TECHNICAL SERVICE BULLETIN

NO. 189-002

- SUBJECT:**
1. NEW STYLE ENGINE HOUSING, FUEL TANK, AND AIR FILTER BOX.
 2. SERVICE AND REPAIR PARTS FOR THE MACHETE BLADE.
 3. OVER PRIMING THE CARBURETOR ON MODELS SO EQUIPPED.
 4. PARTS LIST CORRECTIONS.

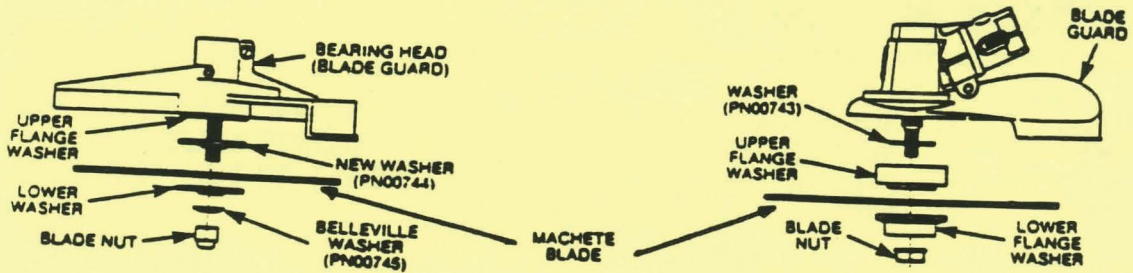
2. Listed below are the repair and service parts available to install, sharpen and repair the Homelite 7" Machete blade.

A-00854
Stringhead
Assembly

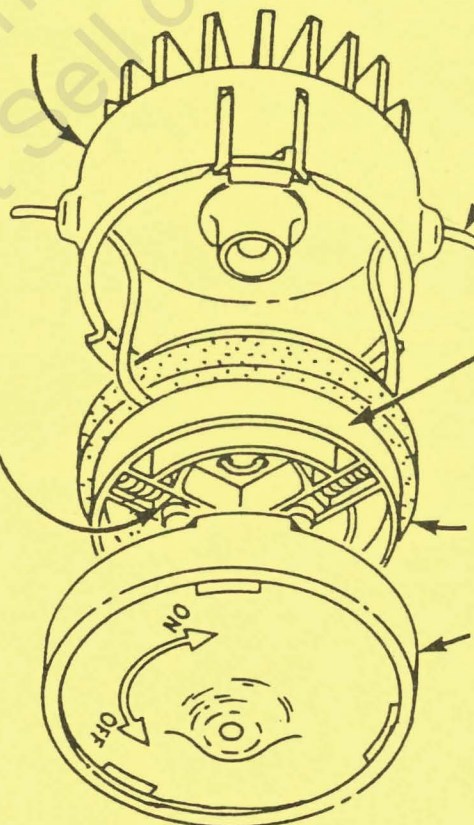
1. Effective with UT-21524-A, the model ST-70 string trimmer is equipped with a new automatic string advance system. This is a dual line system incorporating a set of three identical sliders and springs.

The operation of this new system, unlike the previous idle-line system, is such that the sliders move in and out allowing string to feed automatically while the unit is in operation (without having to release the trigger).

Refer to the illustration below when ordering parts for the new string advance.

Drum & Connector
A-00585-1

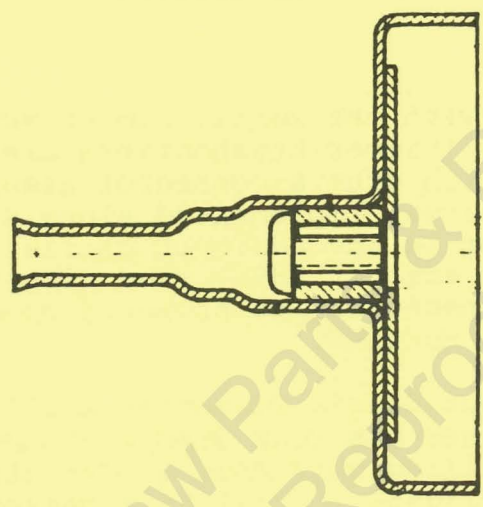
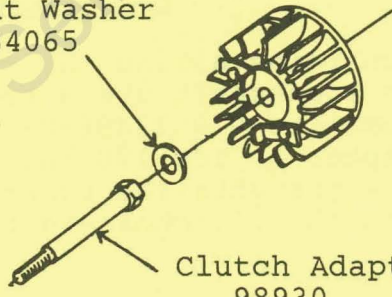
Effective with the serial number shown above all clutch model 25cc trimmer/brushcutters are being built with a formed clutch drum & connector assembly A-00585-1 (see diagram below). Implemented along with the new drum & connector is the addition of flat washer 84065 under the clutch adapter 98930 (see diagram below). This washer is necessary to properly space the drum away from the engine housing.

The previous drum & connector A-00252 is no longer available and has been superseded by the new A-00585-1. When installing this drum & connector on unit made prior to S/N HJ3370950 it will be necessary to install the flat washer 84065 under the clutch adapter. If this washer is not installed, the drum will rub the engine housing.

When reinstalling the clutch adapter onto the crankshaft use a thread-locking agent (Homelite P/N 23488-C) on threads and torque adapter to 100-150 in. lbs. (11,3-16,9Nm). This prevents the adapter from coming loose when the clutches are removed.

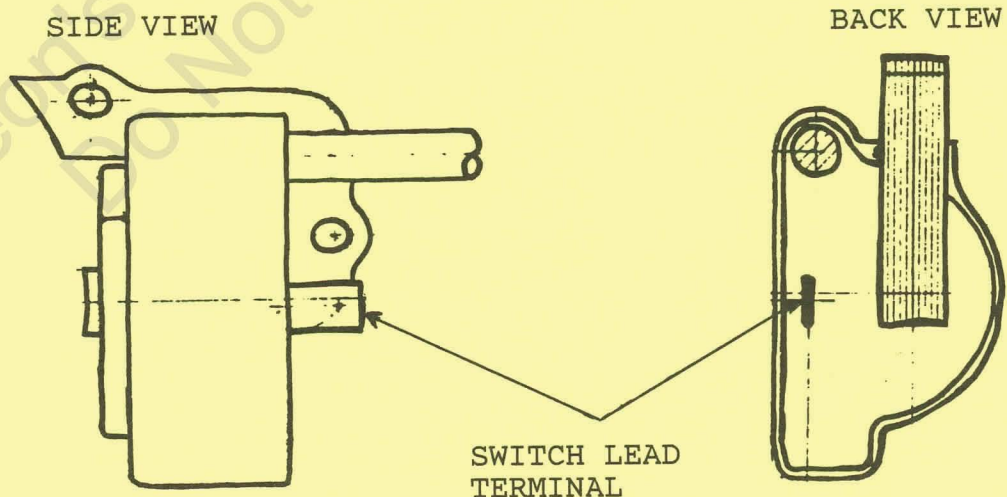
A limited production run of the string trimmer models shown above have been built with a new ignition module developed especially for Homelite.

Refer to the diagram below for identification features of the new module.

In the event of failure, this new module will be serviced with the Phelon module 94711-B (See Service Note Below). ALL FAILED MODULES SHOULD BE RETURNED, WITH THE WARRANTY CLAIM, FOR ANALYSIS.

This new module is completely interchangeable with the Phelon module and is compatible with the Phelon rotor.

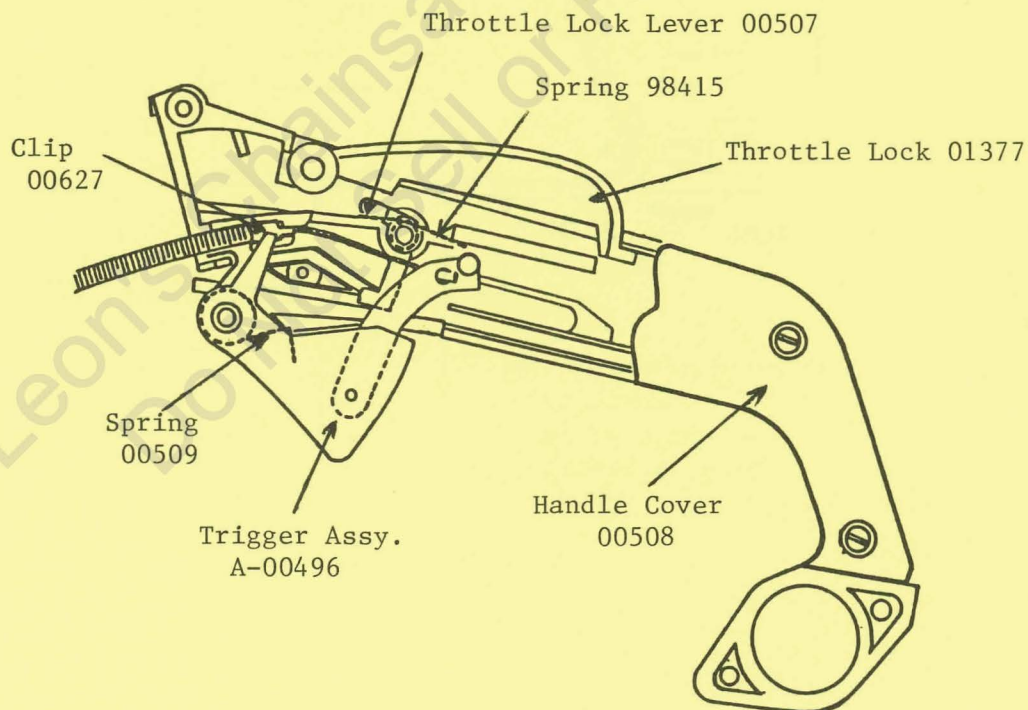
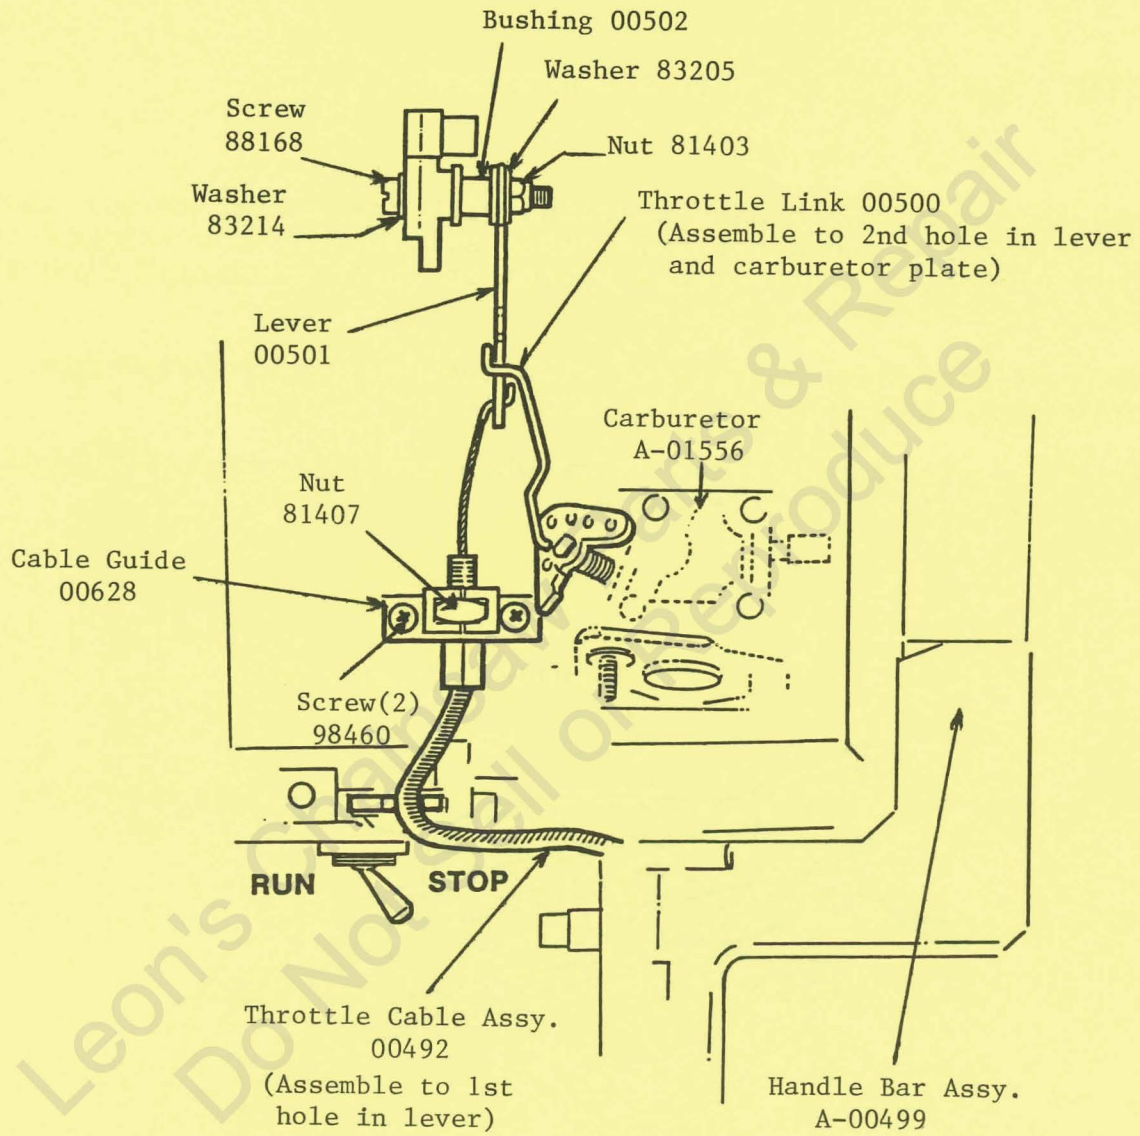
All 340 model Chain Saws starting with the serial number shown above incorporate a throttle cable system from the trigger to the carburetor. This cable system is quite different from the earlier throttle rod design.

None of the parts associated with the new cable system are compatible with the earlier throttle rod design.

Refer to the two diagrams below when ordering parts for units built with the throttle cable.

CARBURETOR (WALBRO WJ-24)	A-49510
REPAIR KIT	49672
GASKET/DIAPHRAGM KIT	97941
MAIN NOZZLE (.026")	49539
INLET NEEDLE	97942

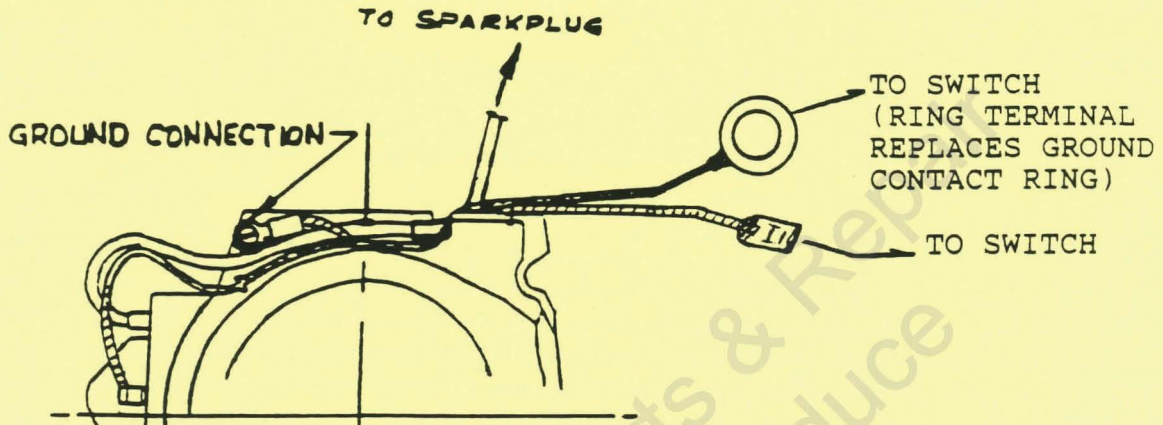
1. For improved reliability, the models 540SL and 540SLF effective with the serial number shown above are now being built with a fixed jet carburetor A-49510 (Walbro WJ-24). Although this carburetor has a fixed main jet it is also equipped with a hi-speed trim needle which allows for a certain amount of flexibility and fine tuning. The design of the carburetor permits it to be adjusted richer but cannot be set any leaner (hi-speed closed) than the main jet allows (similar to the SXL-925 carburetor).

Repair parts available to service the fixed-jet carburetor are listed below and should be added to your 540 Parts List (18087).

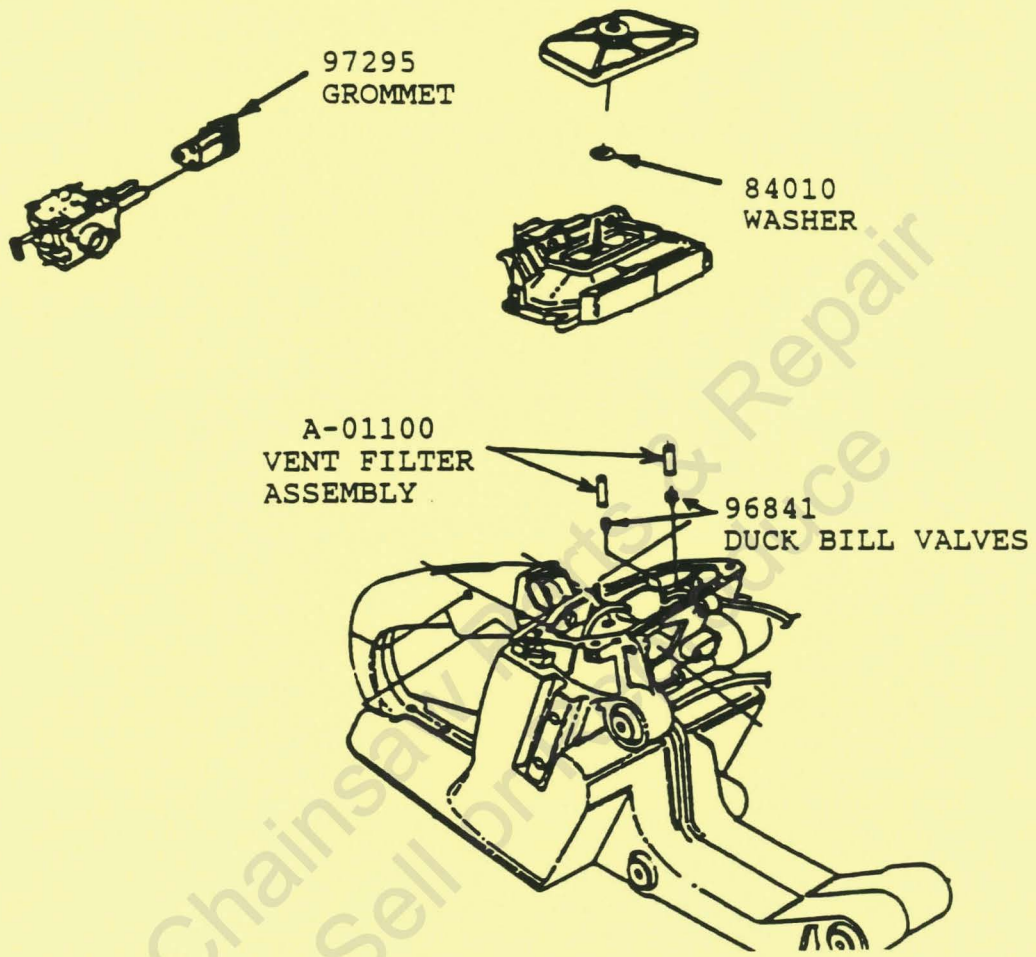
3. Effective with Lot # HJ074 new fuel and oil tank vent filters A-01100 have replaced the earlier sintered bronze filters 00788. The new filter assembly consists of a porous filter (white in color) pressed into an aluminum sleeve. The filter assemblies should be installed with the porous white filter facing up.
4. Along with the new vent filters mentioned in Item #3 the sealing of the carburetor chamber was improved by replacing the three (3) translucent yellow carburetor adjustment needle sleeves (00038 & 00039) with a molded rubber grommet 97295 and adding a flat washer 84010 under the air filter element to prevent it from bowing when the retaining nut is tightened.

During installation of the carburetor (with the grommet) make sure the grommet face seats and seals against the left side of the carburetor chamber. The flat washer should be installed and centered over the air filter mounting bracket stud, making sure it lays flat, use a cyanoacrylate adhesive (i.e. Super Glue) to hold it in place.

Refer to diagram below for illustration of Item # 3 & 4.

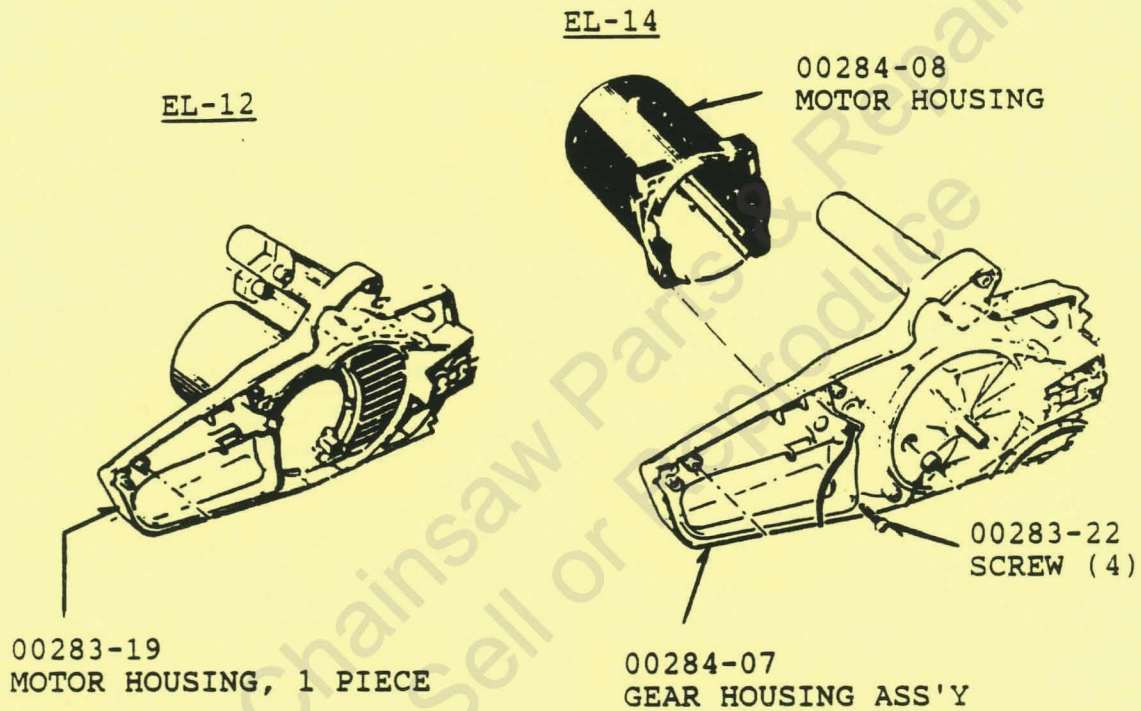
2. The EL-12 and 14 Parts List (18018) is somewhat unclear as to the part numbers of the motor housings and gear housing (EL-14 only). For clarification, please refer to the diagram below.

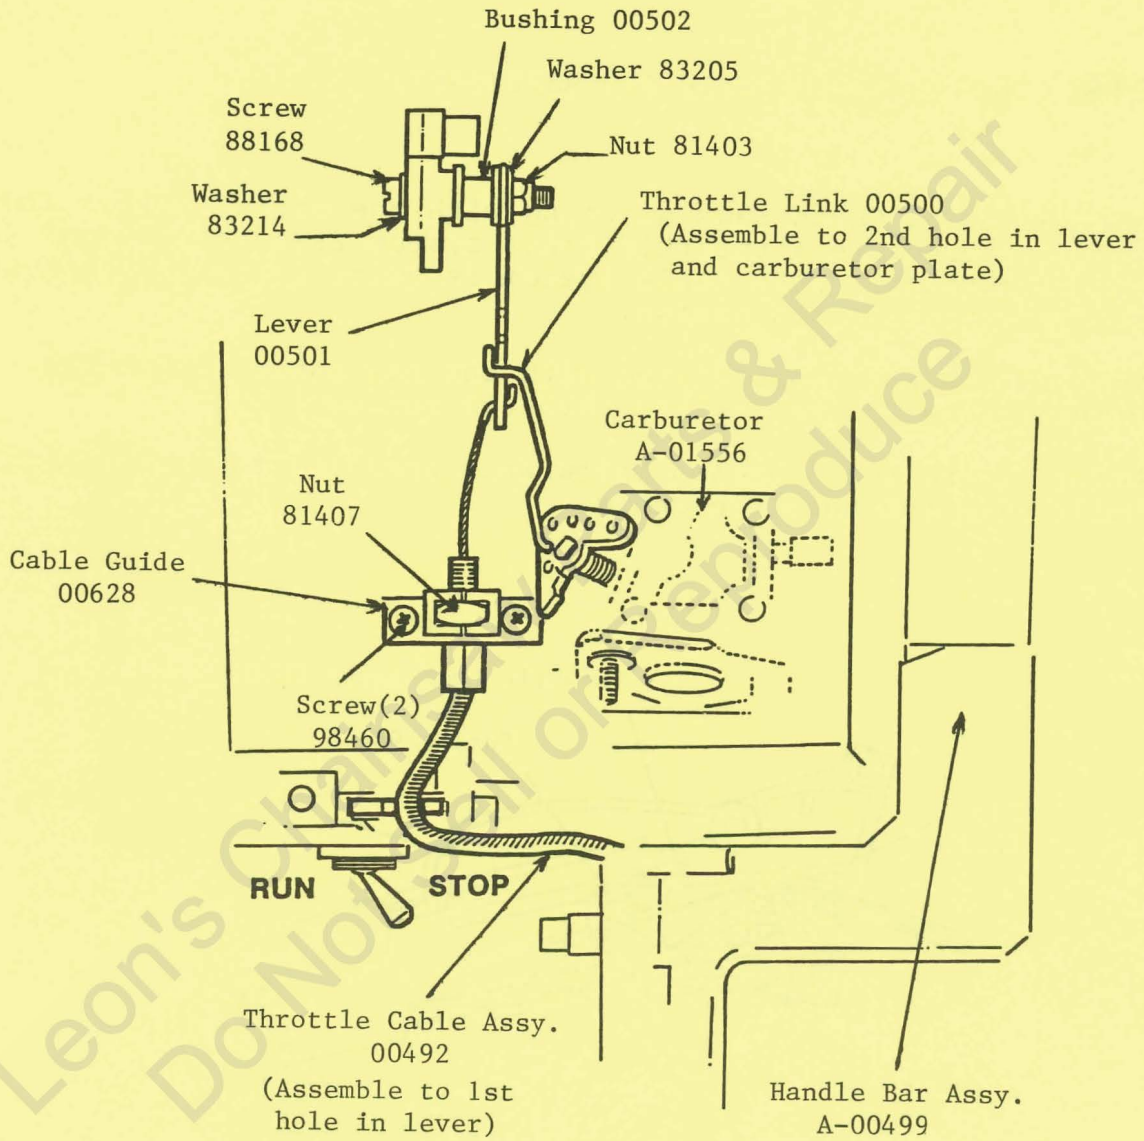
All 340 model Chain Saws starting with the serial number shown above incorporate a throttle cable system from the trigger to the carburetor. This cable system is quite different from the earlier throttle rod design.

None of the parts associated with the new cable system are compatible with the earlier throttle rod design.

Refer to the two diagrams below when ordering parts for units built with the throttle cable.
